Submission to

Casey Fields South Employment & Devon Meadows PSP, DSS & Amendment C295case

1490 Ballarto Road, Devon Meadows

Issued
31 March 2025

Figure 5: 1490 Ballarto Road Masterplan

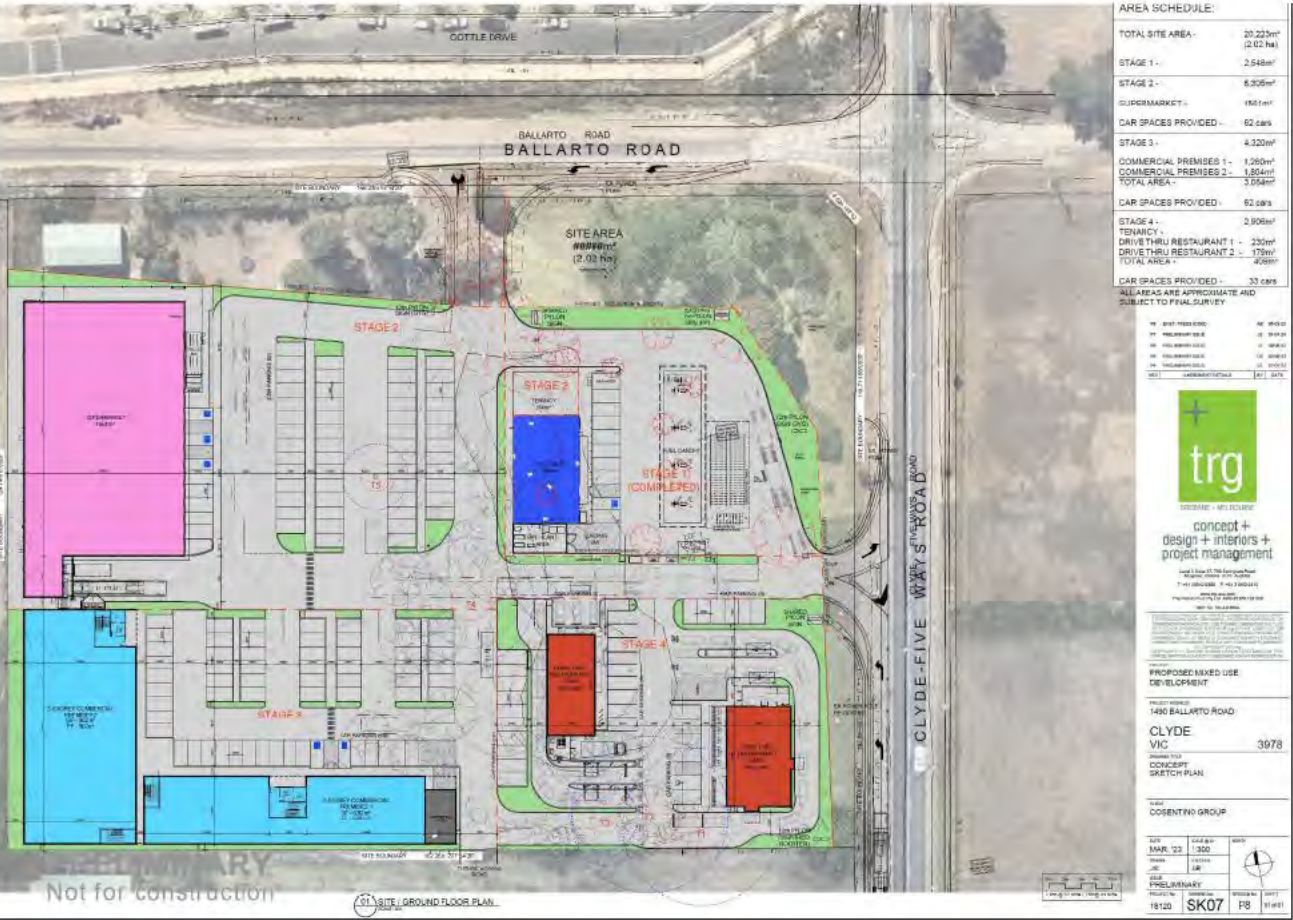
It is submitted that the 5 trees located on site will need to be removed to facilitate a functional road movement and logical subdivision layout, as well as appropriate connections to adjoining properties and the arterial road network. The trees are not highly regarded, have clear deficiencies in their health and structure and do not support longevity.

It is requested that Plan 13 of the PSP be updated to remove all trees from the site to reflect its current status, and to eliminate the unnecessary need for a planning permit to remove the remaining native vegetation as part of a future planning permit application post PSP gazettal.

Figure 8: Melbourne Water Catchment Areas. (Source: GHD 2024)

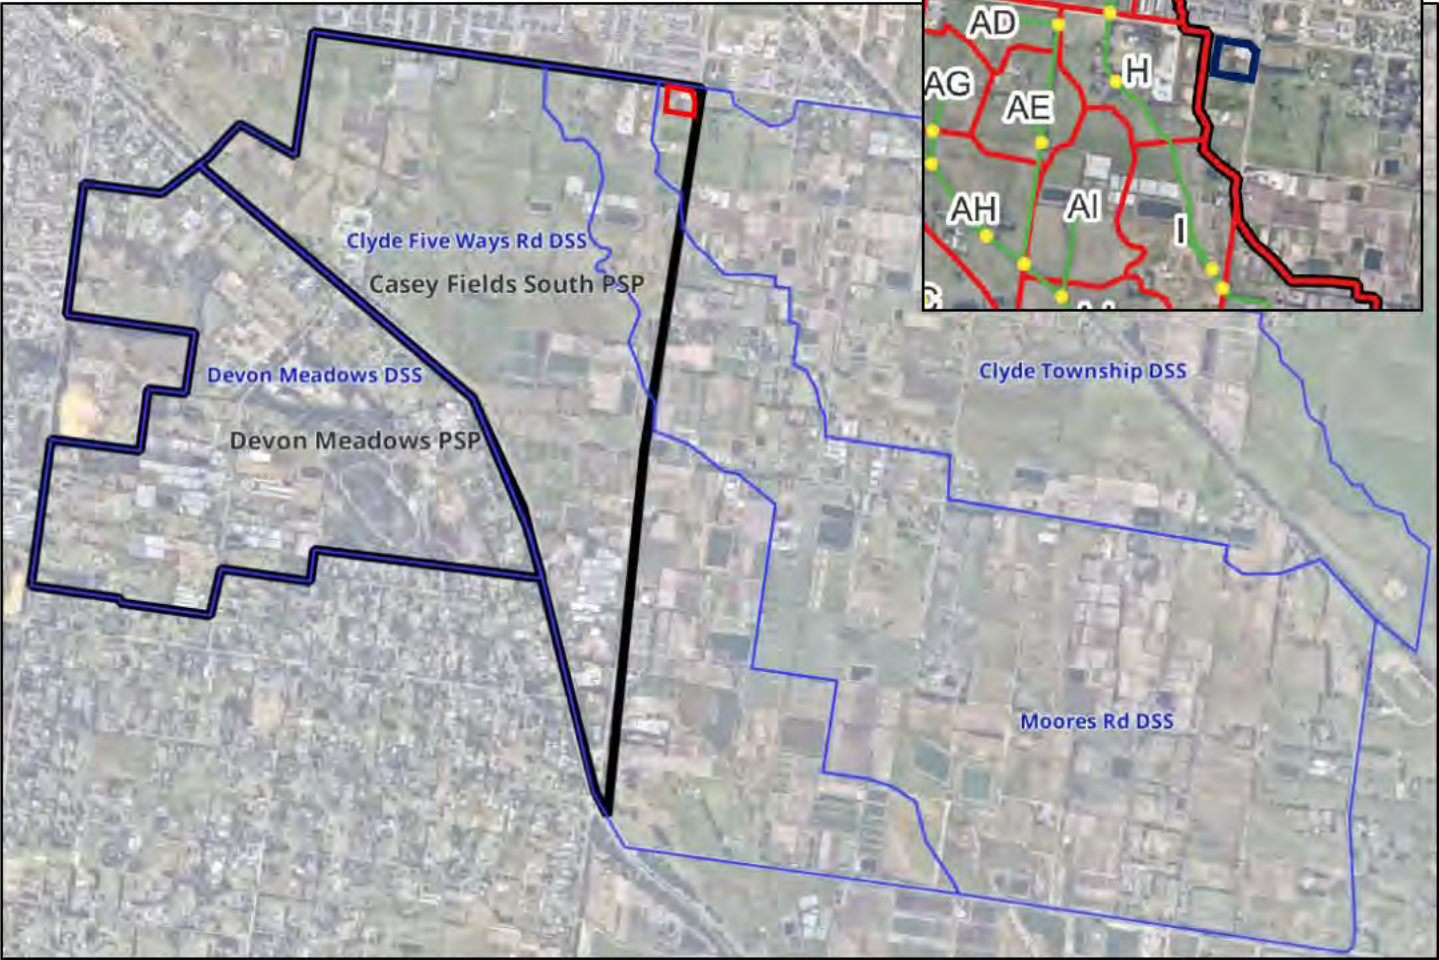
The property at 1490 Ballarto Road is not within the CFS&DM drainage scheme area but instead falls under the Clyde Township drainage scheme. Therefore, the staging requirements outlined in R27 should not apply to the subject land. The property is also adjacent to the Clyde township and an established residential precinct, with services already extended to support the existing service station. Given these factors, there is no logical reason to delay the development of this site.

It is submitted that Plan 9 – Infrastructure and Development Staging be updated to remove property ID #CF09 from the staging plan.

Figure 4: Proposed works – T4

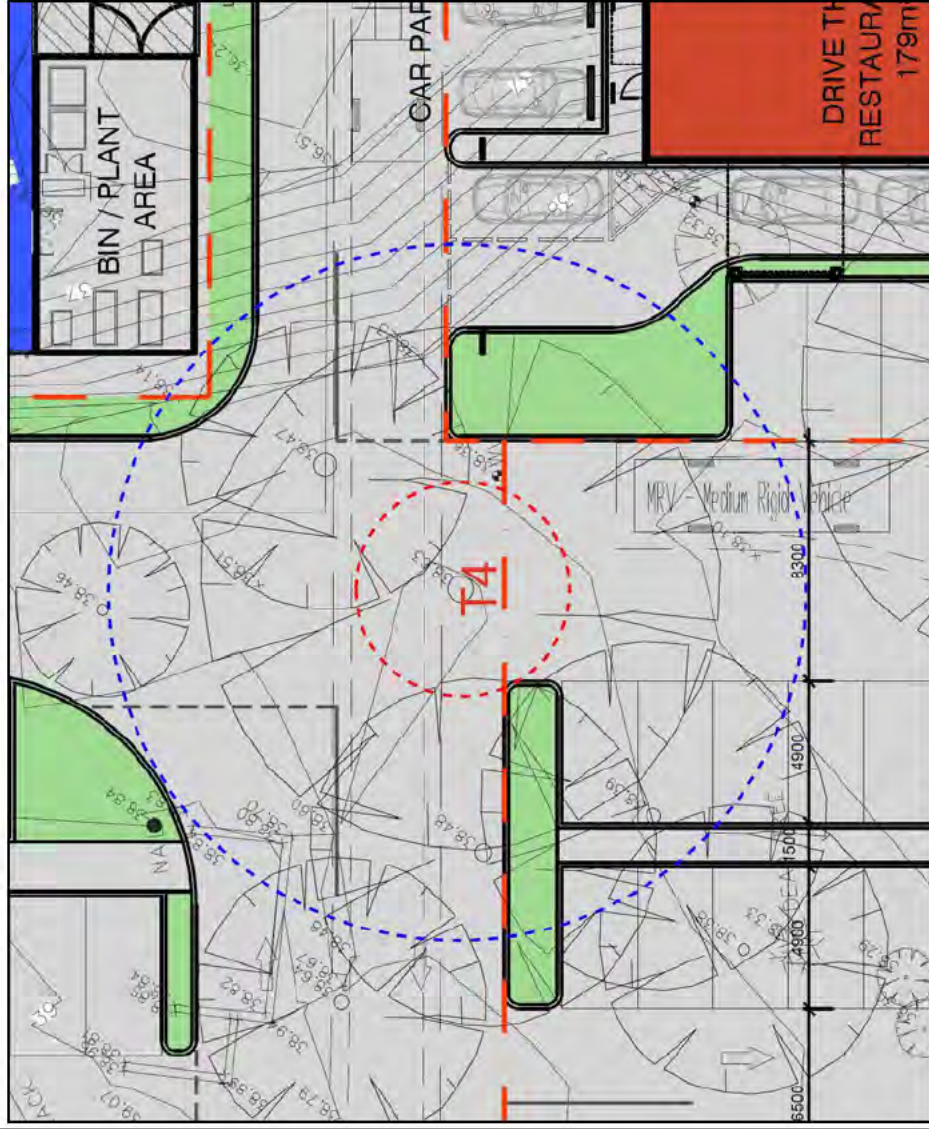
Tree #	I.D	Proposed Encroachment	% of TPZ Area Encroached	Likelihood of Impact to Tree Health & Stability	To be Removed	Comments & Recommendations
						T3 should be removed.
						Onsite The development proposal includes an internal road which is a main entrance/exit for vehicles and semi-trailer access for the supermarket. The works are proposed over the location of T4.
4	<i>Corymbia maculata</i>	Internal road, semi-trailer access to supermarket	100% Works proposed over location of tree.	Unretainable	Yes	T4 is multistemmed from ground level. It presented with compression forks and included bark with swelling. The structure is codominant. A large suspended broken branch is located to the North. T4 is not viable in the long term and is not an appropriate tree to retain within this development proposal due to the defects observed. The retention value of T4 is Low due to the poor structure and the ULE is short.

T4 should be removed.
						Onsite The development proposal includes a car park for the supermarket. The works are proposed over the location of T5.
5	<i>Corymbia maculata</i>	Internal road, Carparking	100% Works proposed over location of tree.	Unretainable	Yes	T5 presented with poor structure, included bark and compression forks. Swelling was observed around the included bark union. The canopy was sparse and canopy dieback and broken branches were observed. T5 is not viable in the long term and is not an appropriate tree to retain within this

Figure 5: Proposed works – T5

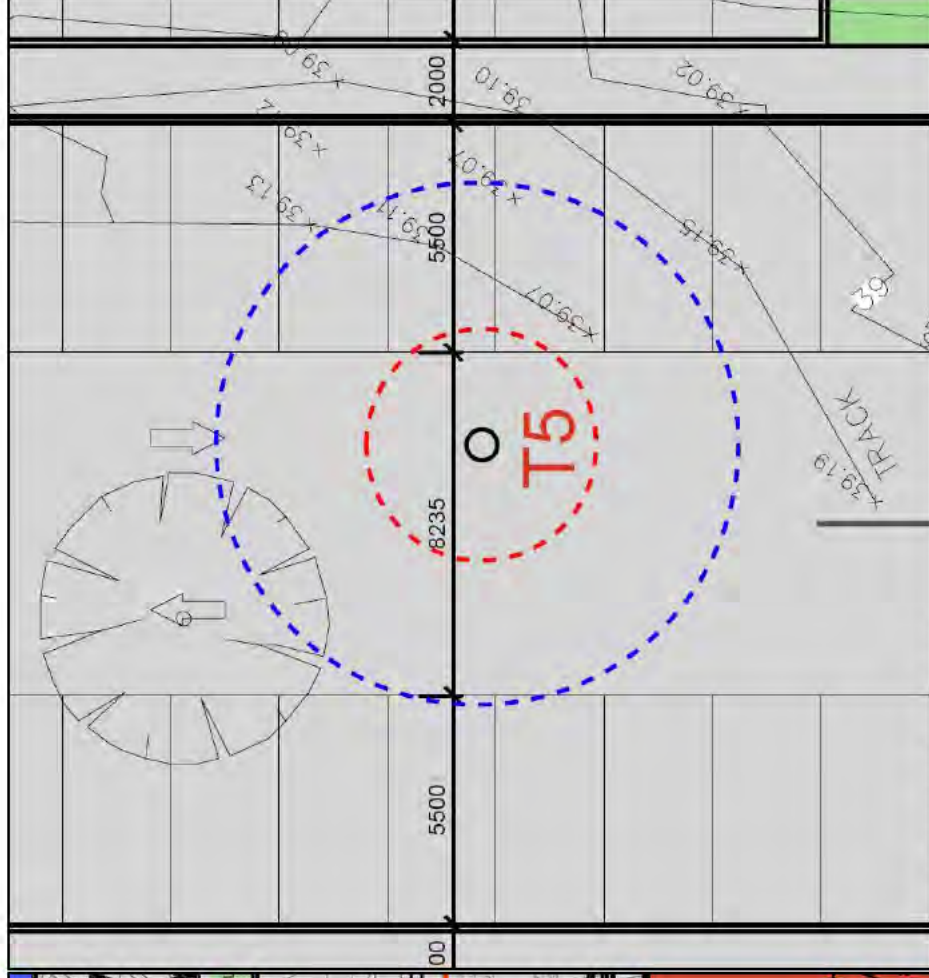
Tree #	I.D	Proposed Encroachment	% of TPZ Area Encroached	Likelihood of Impact to Tree Health & Stability	To be Removed	Comments & Recommendations
						development proposal due to the defects observed.
						The retention value of T5 is Low due to the poor structure and the ULE is short.
						T5 should be removed.
